HYDRAULIC DESIGN DEVIATION REQUEST

Section:	Pudding River (Whiskey Hill Road) Bridge #01559	Route No:	C.R. 42036
Highway Name:	Whiskey Hill Road	Hwy. No:	N/A
County:	Clackamas & Marion	Milepost:	2.6
Region:	1 & 2	Key No:	17408
Bridge #	01559	EA No:

WHISKEY HILL 3-LINE PROFILE

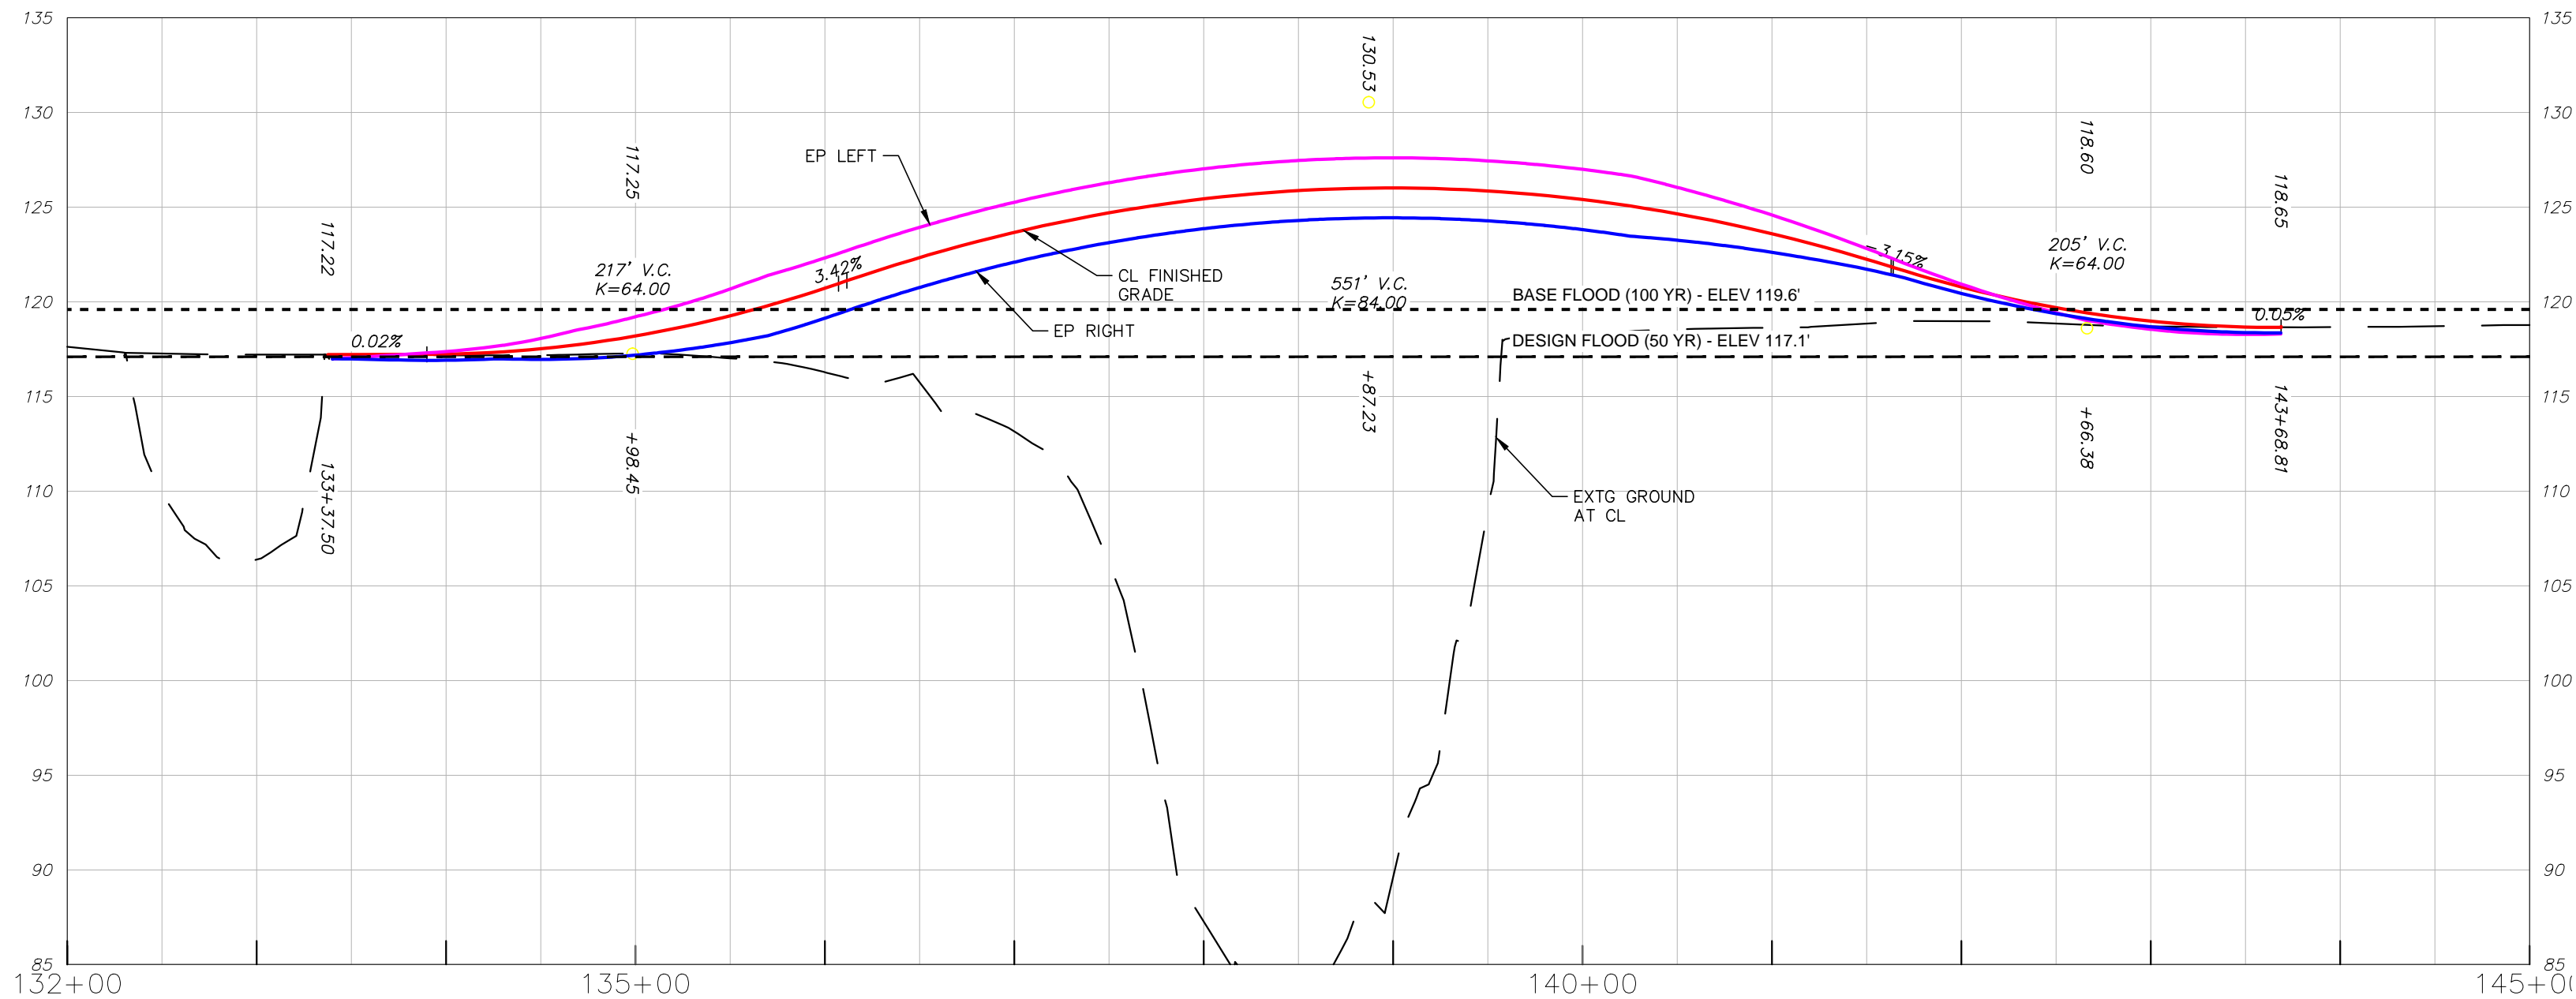
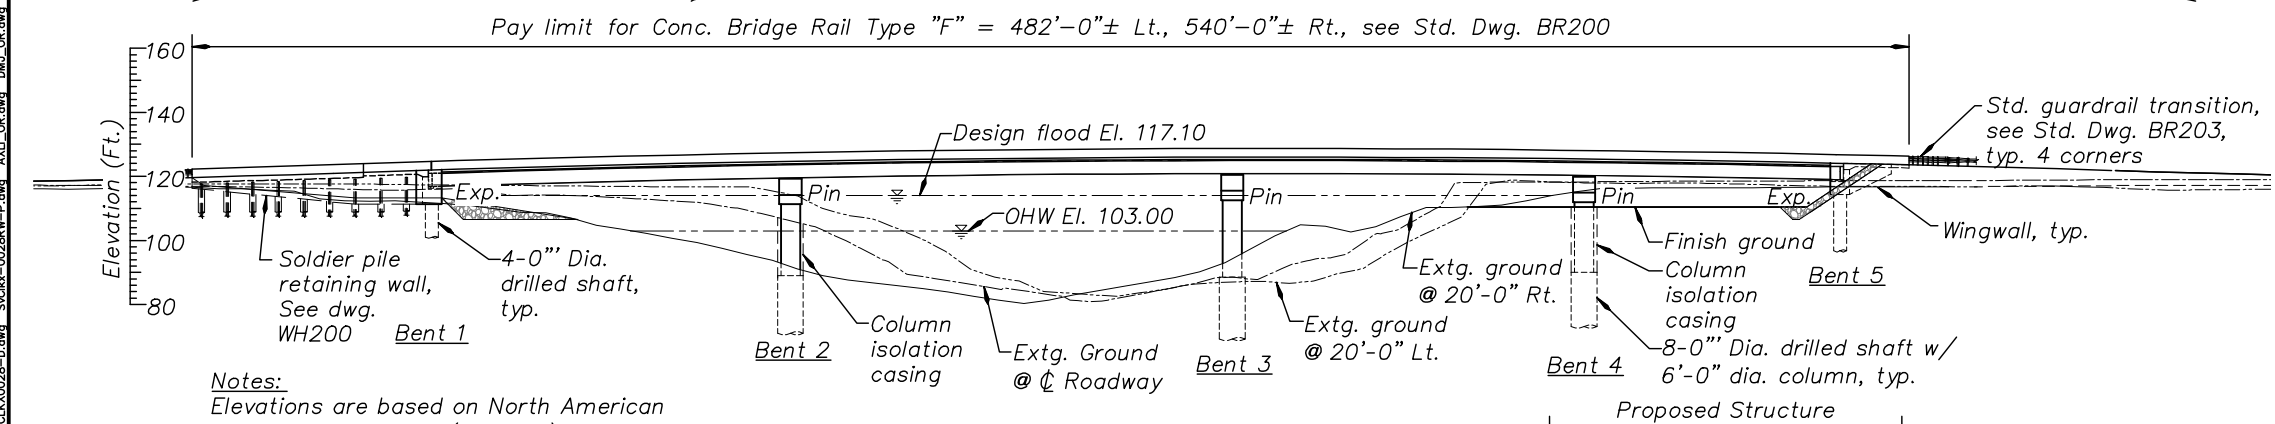
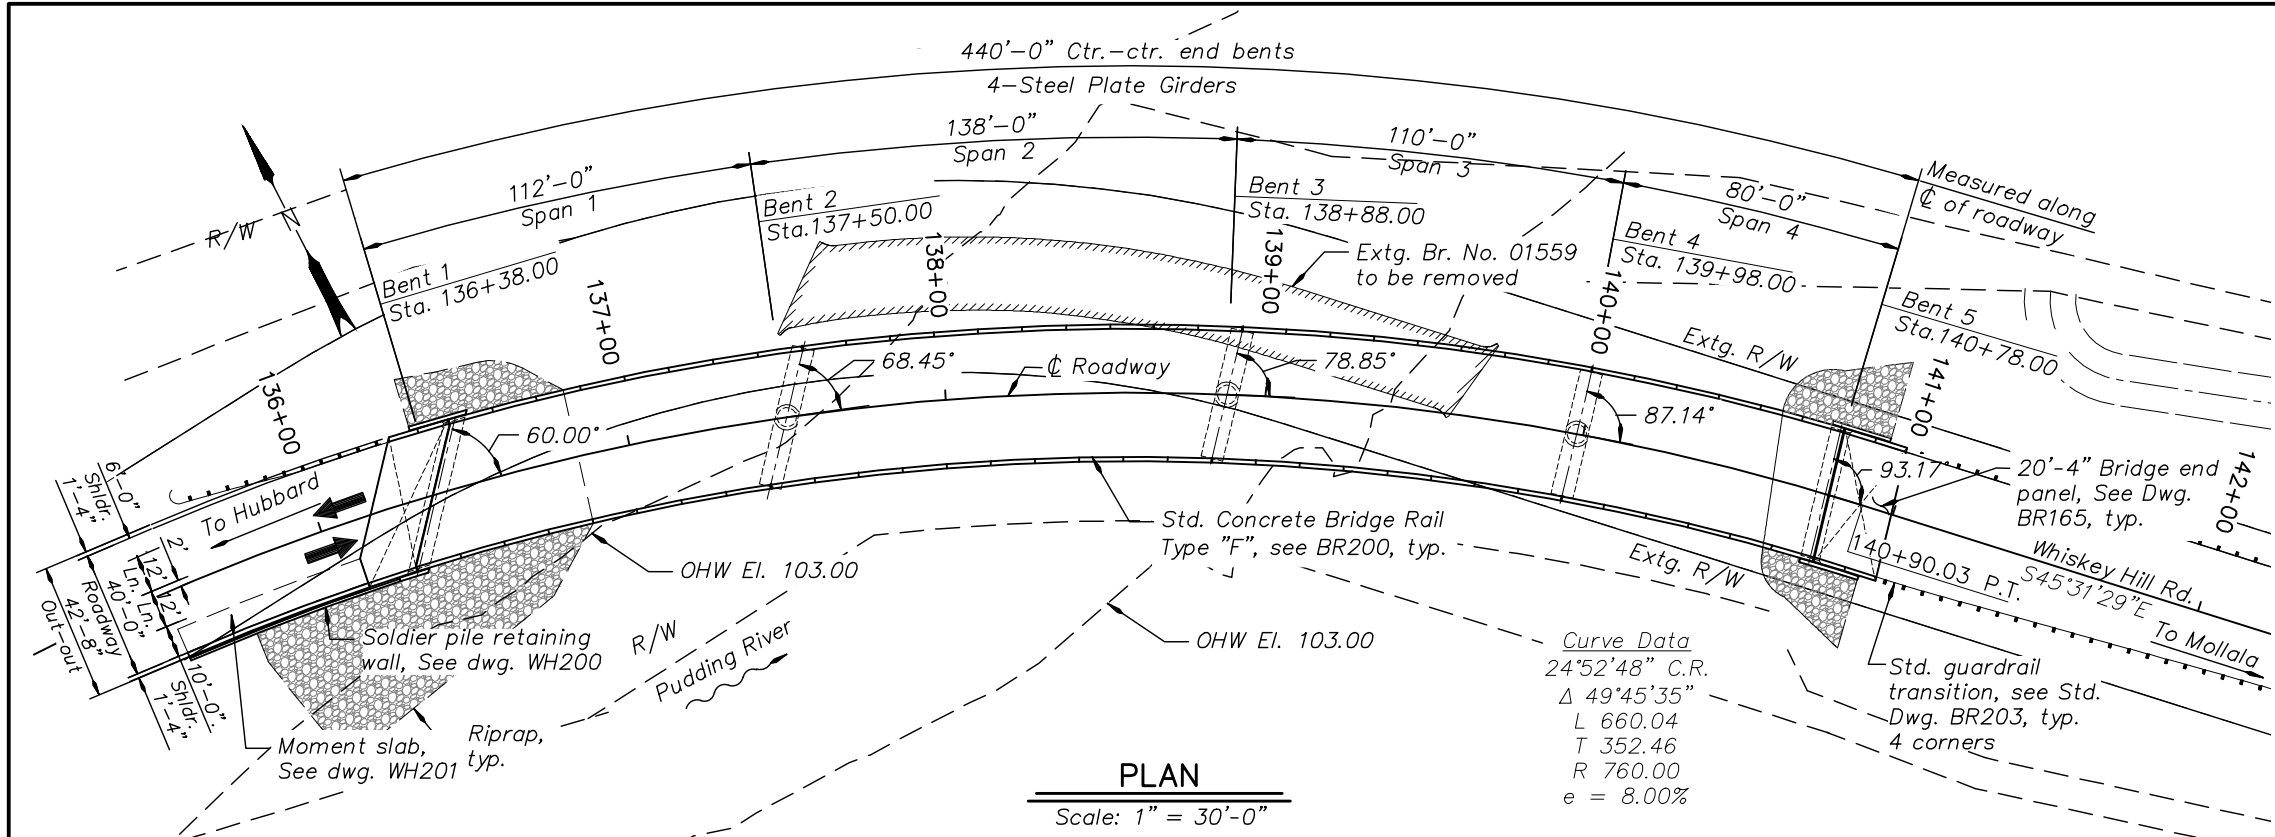
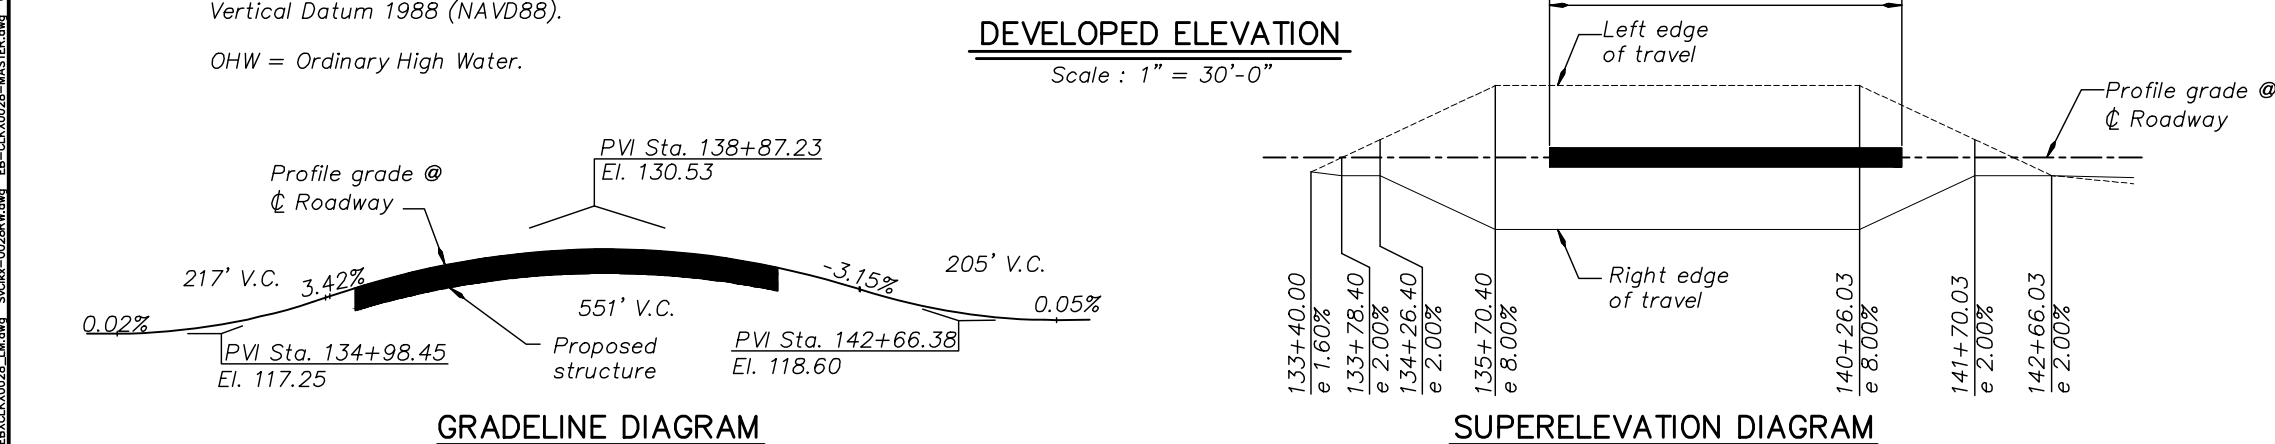
It is anticipated that flooding from the Pudding River may encroach onto the Whiskey Hill Road with incipient overtopping flow that has a recurrence interval of approximately 33 years and a high water elevation 116.3 at the upstream face of the bridge. This is approximately the elevation of the existing inside edge of pavement on the westerly approach at the low point of the sag vertical curve. The 50-year design flood is at elevation 117.1. The proposed west and east approach roadway profile is about elevation 117.3 and 118.7, respectively. The replacement structure has been designed to avoid additional backwater during the 100-year base flood. This has been achieved by balancing an increase in both the bridge length and hydraulic opening with a reduction in conveyance of floodwaters that currently overtop the roadway. For the 100-year flood, water will overtop the road by as much as 2.3 feet on the west approach and about 0.9 feet on the east approach. See attached 3-line profile for additional information.

Reasons for Not Attaining Standard:
<ul style="list-style-type: none"> The west approach to the bridge would need to be raised 3.23 feet to provide the 1 foot minimum requirement. Overall, the design of the replacement bridge provides 2.3 ft. of freeboard at the crest of the vertical curve to allow for debris passage. The increased length and opening of the new bridge will improve the conveyance of flood water and resulting in a no net-rise for the backwater elevation. The backwater elevation is expected to reduce from 2.05 ft. from the existing bridge to 1.52 ft. for the new bridge meeting the 50-year design flood It would require a much longer continuous structure to offset the loss of conveyance of floodwaters that would otherwise overtop the roadway in order to achieve a no-rise condition during the 100-year base flood. This would also necessitate replacement of the existing overflow structure immediately to the west. The planning level estimated cost to replace the overflow structure is approximately \$2 million. The following is a breakdown of this cost: <ul style="list-style-type: none"> Overflow Bridge – 105 ft x 42.75 ft x \$200/sf = \$897,750 Additional Bridge Length of Proposed Bridge – 20 ft x 42.75 ft x \$400/sf = \$342,000 Retaining walls at road approach to minimize EFU impacts – 2 walls x 150 ft x 5 ft x \$40/sf = \$60,000 Roadway items = \$100,000 Contingencies at 20% = \$279,950 Design/redesign = \$400,000 Furthermore, the existing overflow bridge is approximately 105 feet long. The bridge length cannot be increased to provide additional conveyance of the Pudding River because it is adjacent to private property (zone exclusive farm use). Additional conveyance is required to offset raising the elevation of the road approaches in the floodplain to meet the increased bridge elevation. Therefore, the length of the proposed bridge would need to be increased to provide adequate conveyance of the river. In conversations with adjacent property owners, the owners are supportive of the project but very concerned about river/hydraulic impacts to their properties with the potential changes in the overflow pattern. In summary, the proposed roadway and bridge elevations provide the best balance within this section of the Pudding River floodplain. The proposed design will essentially maintain the current condition for overtopping of the Whiskey Hill Road on the west approach to the bridge. The frequency of overtopping will be slightly increased to a 35-year recurrence interval from the existing of 33 year recurrence interval.
